REDTAIL RANCH FILING NO. 1

CONSTRUCTION DRAWINGS

PCD No. SF-18-021

Markup Summary

REDDAIL RANCH FILING NO. 1
STREET IMPROVEMENT PLAN
WARD LANE & VOLLER ROAD

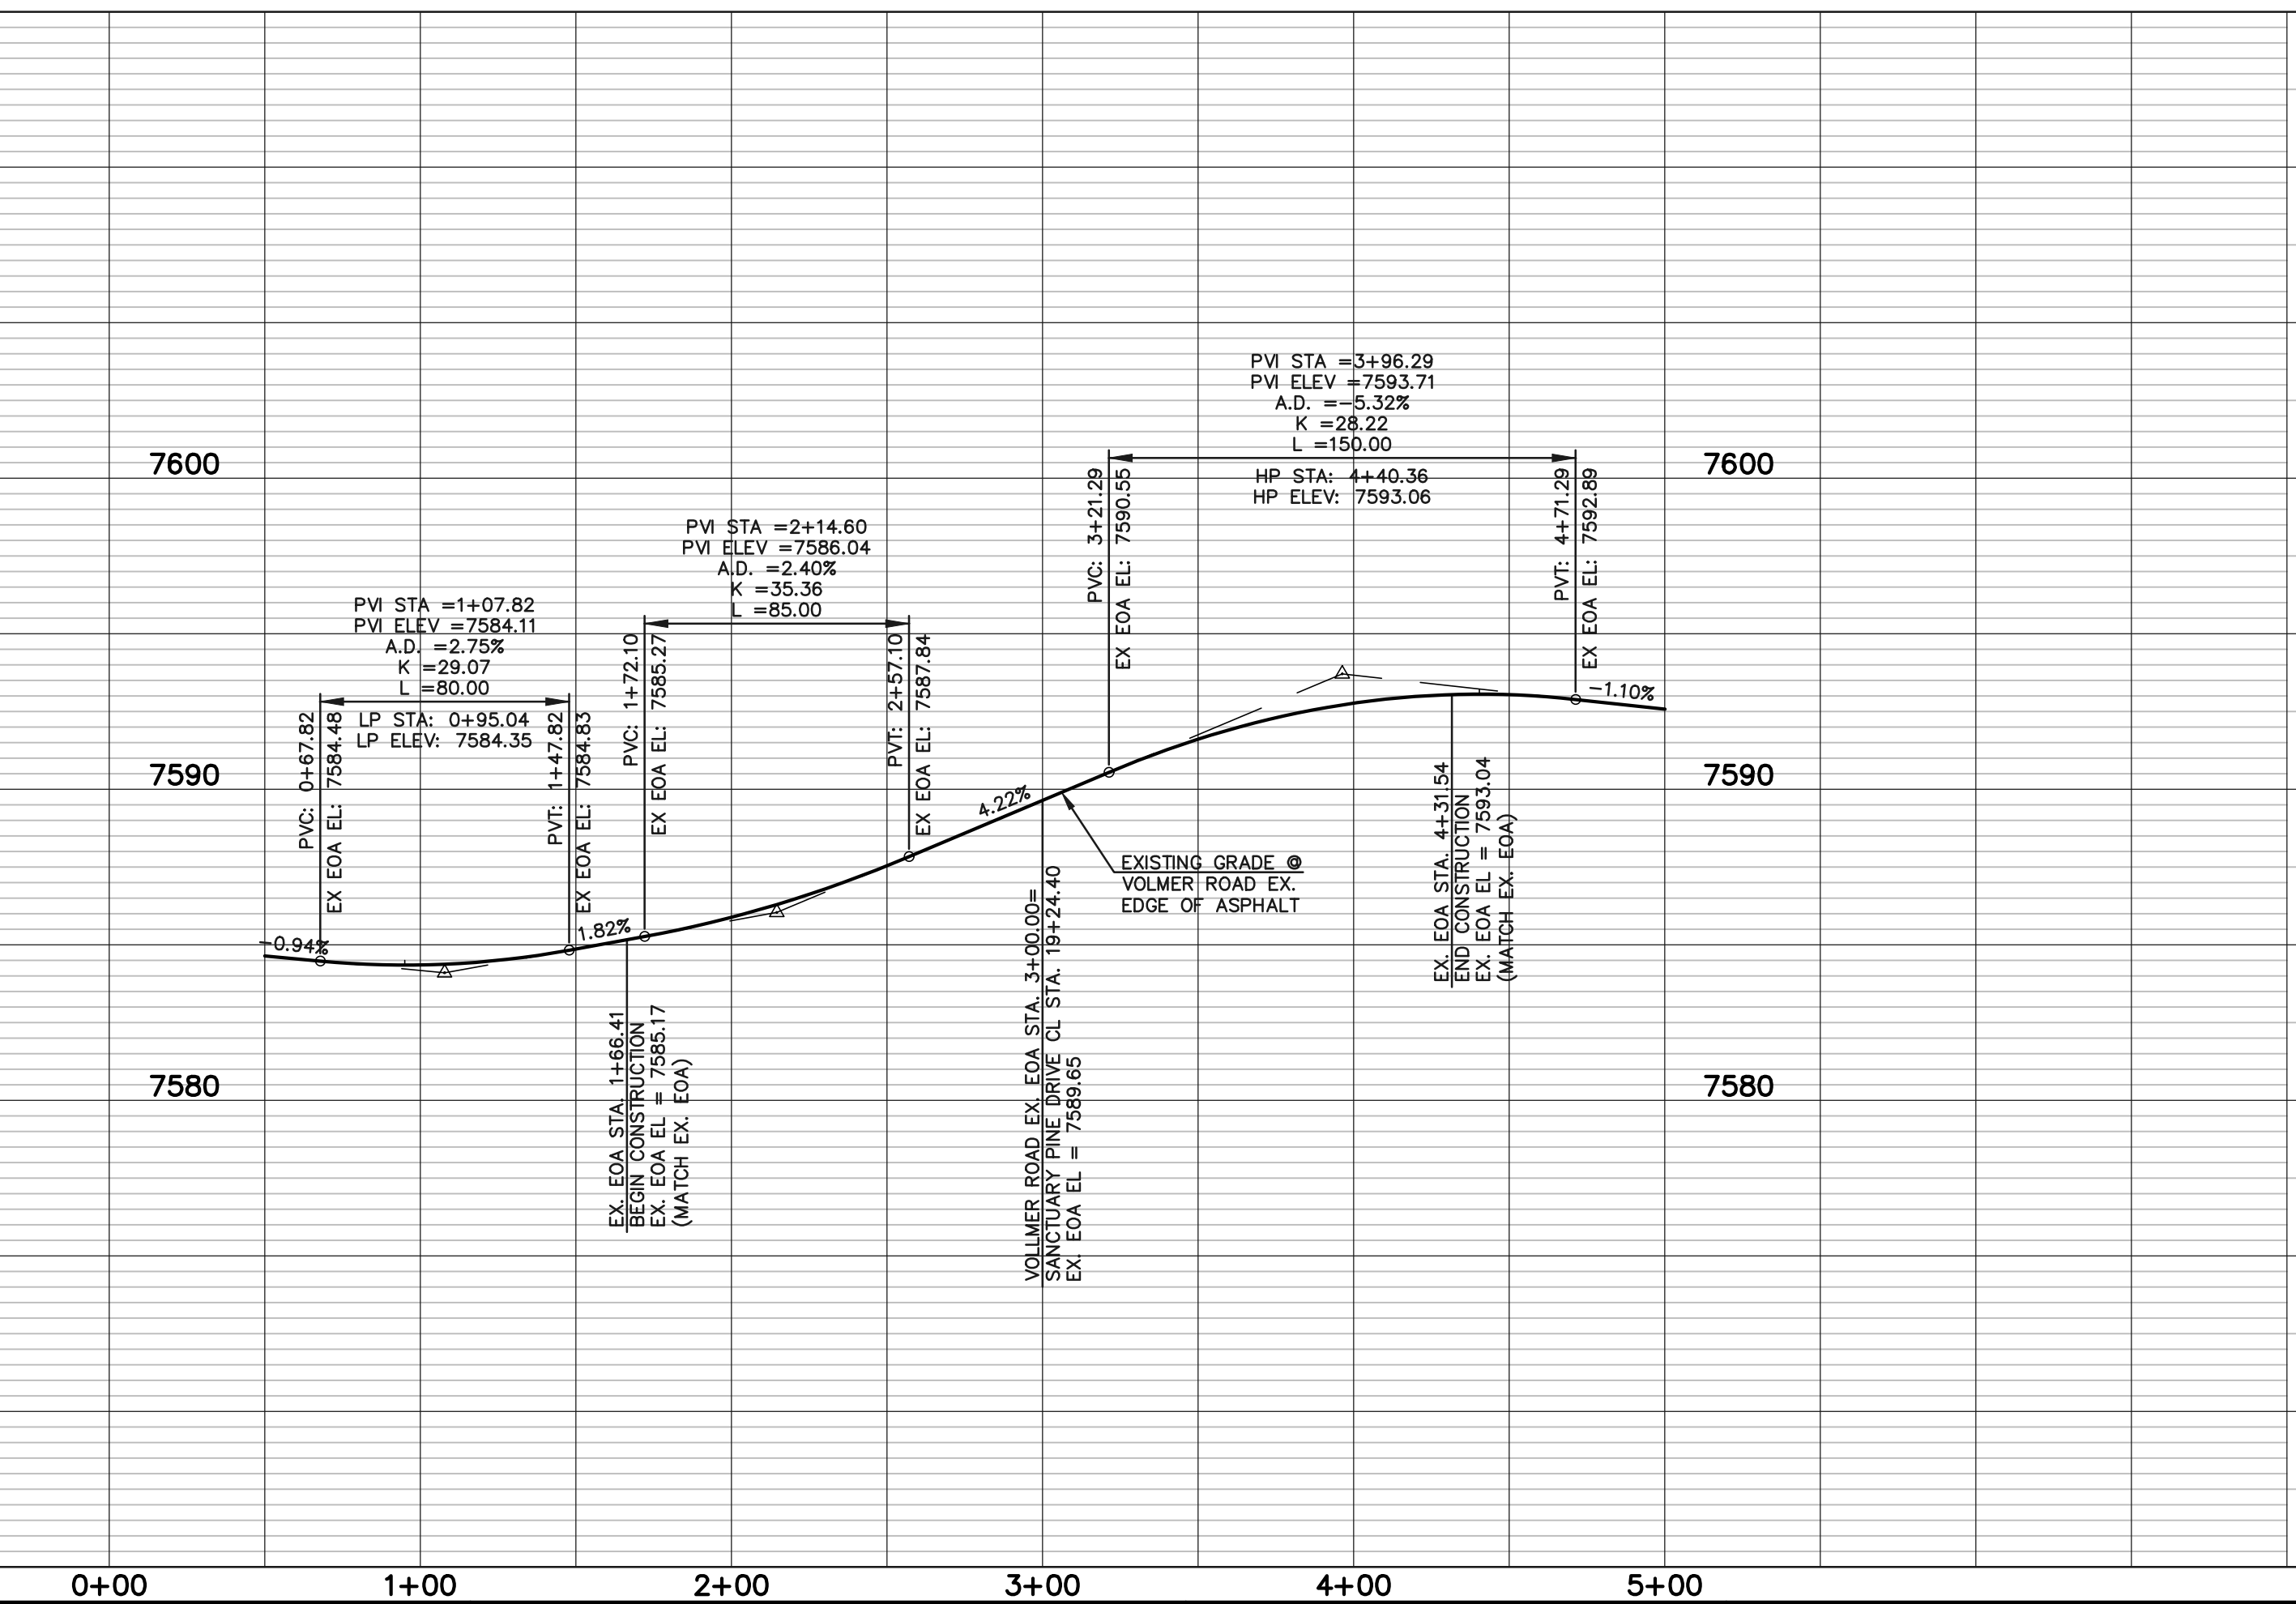
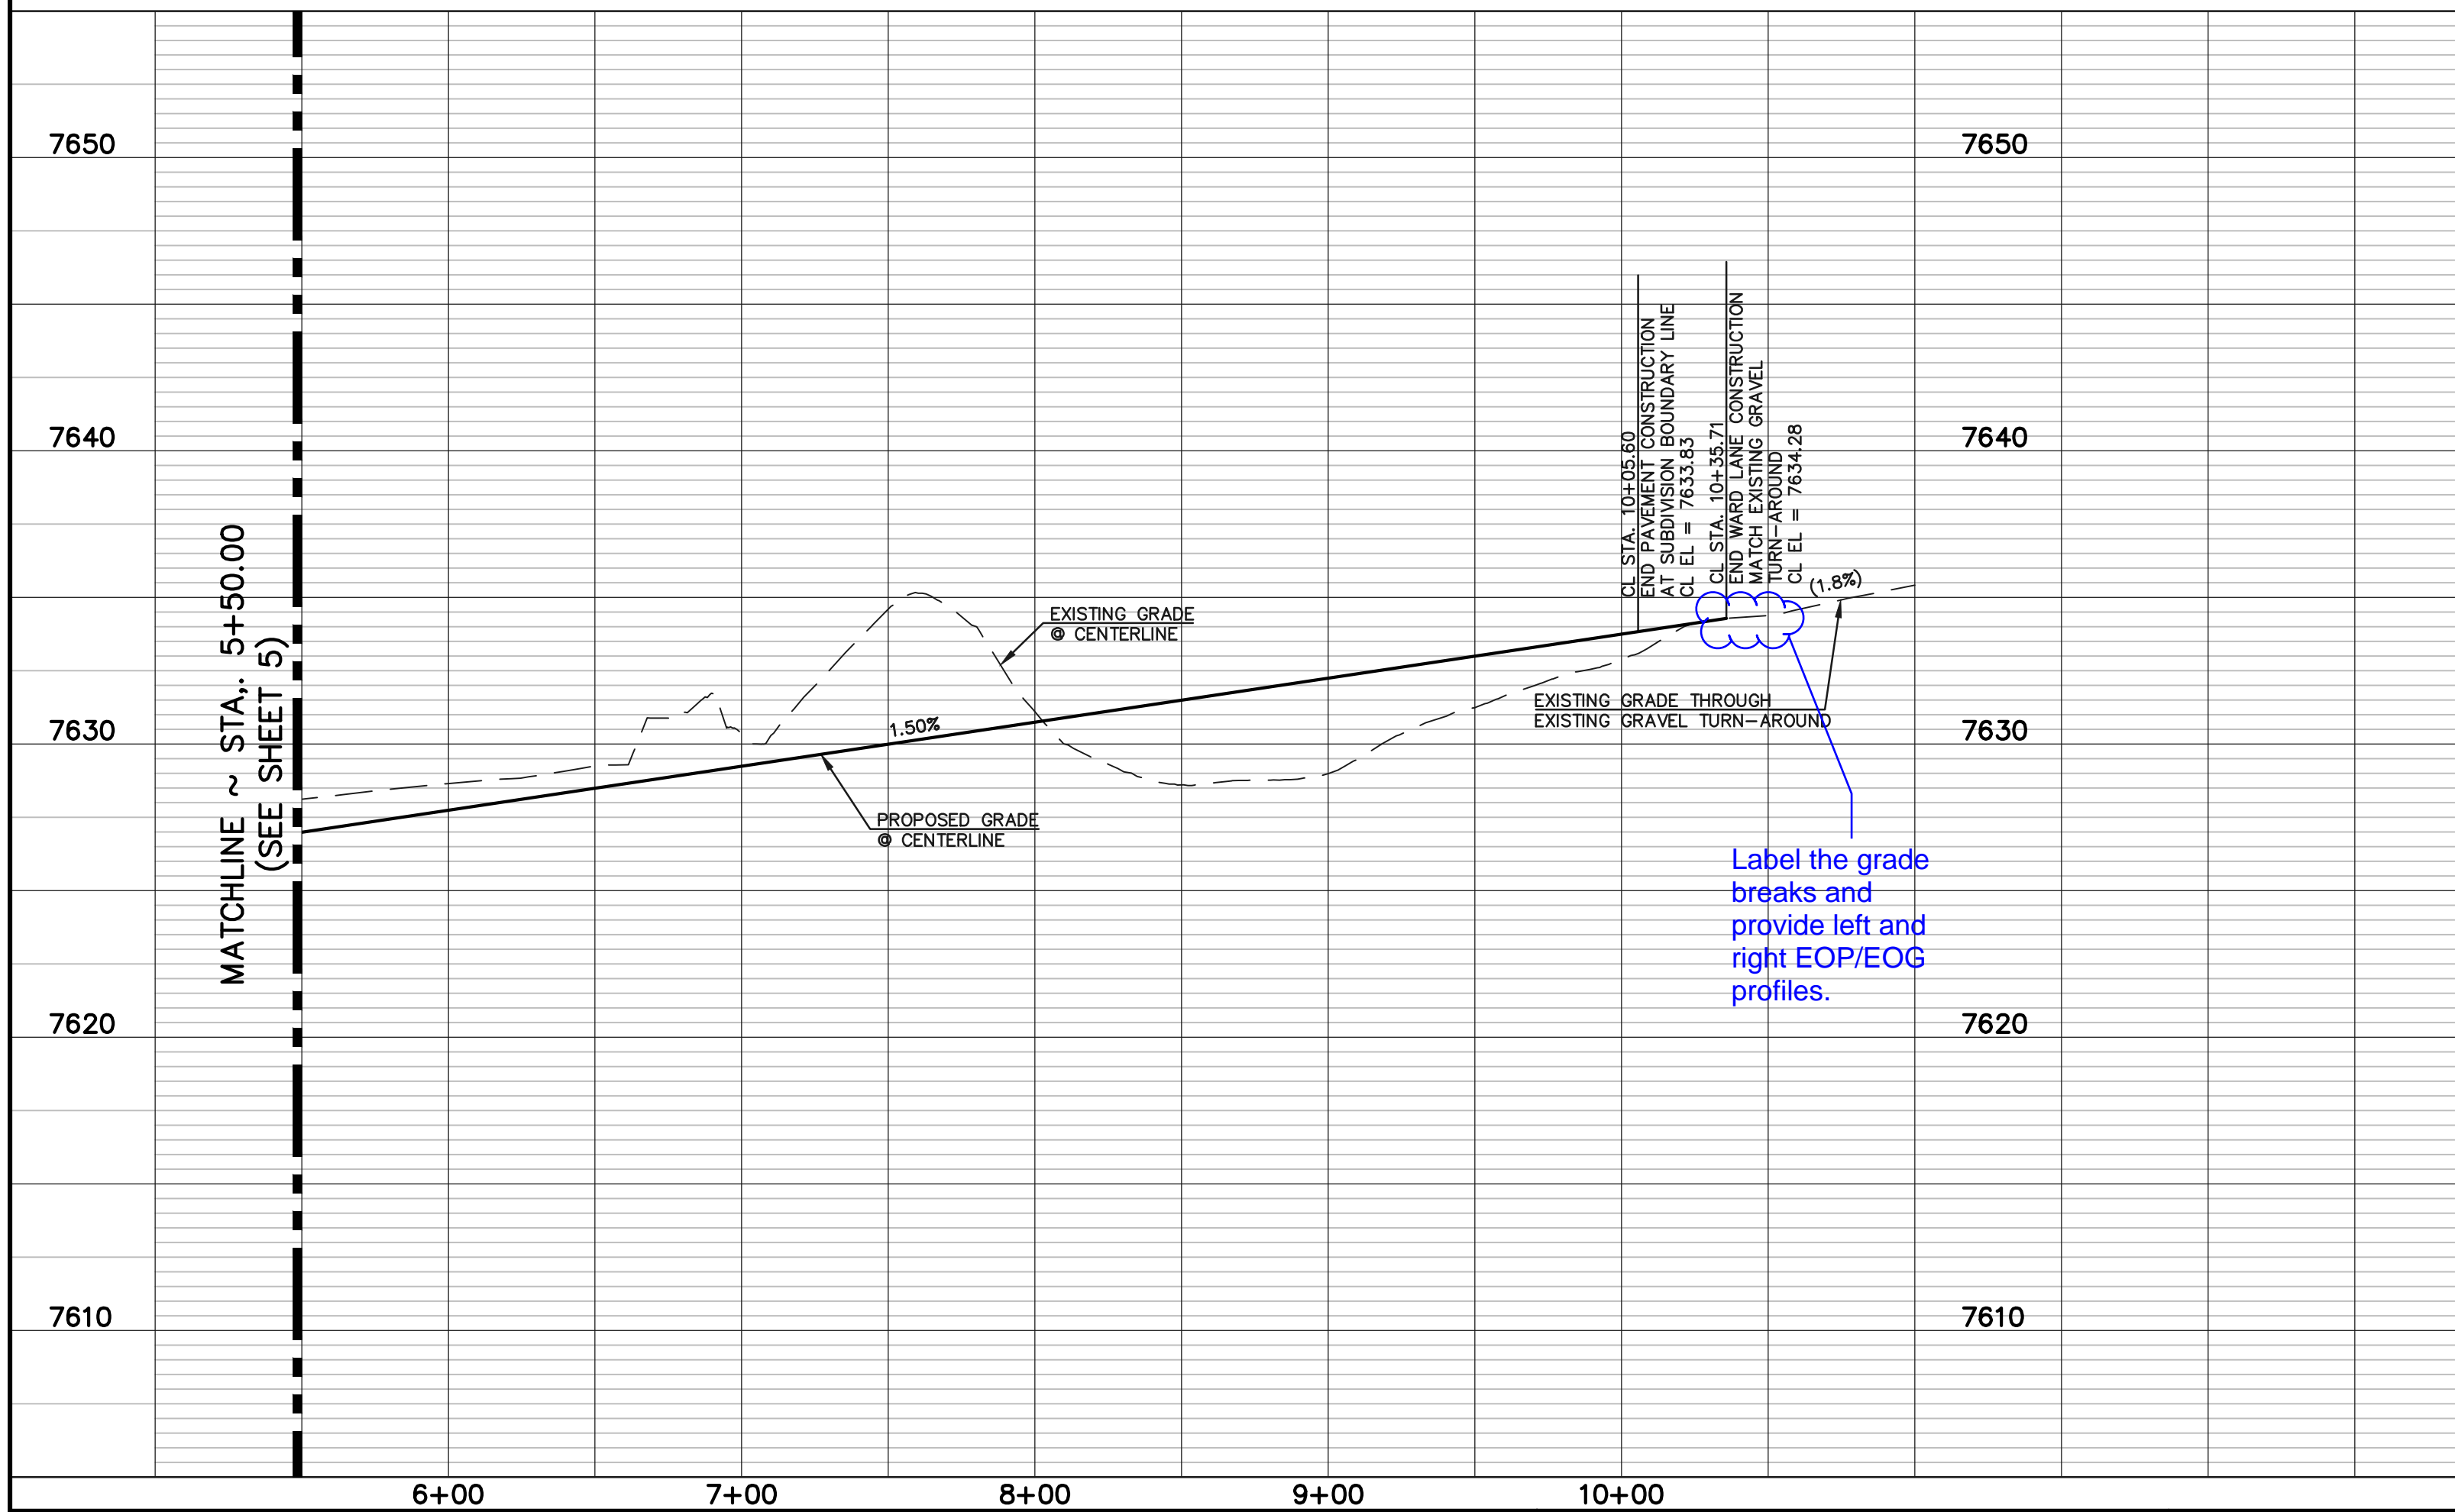
Include shoulder improvements called for in the TIS.
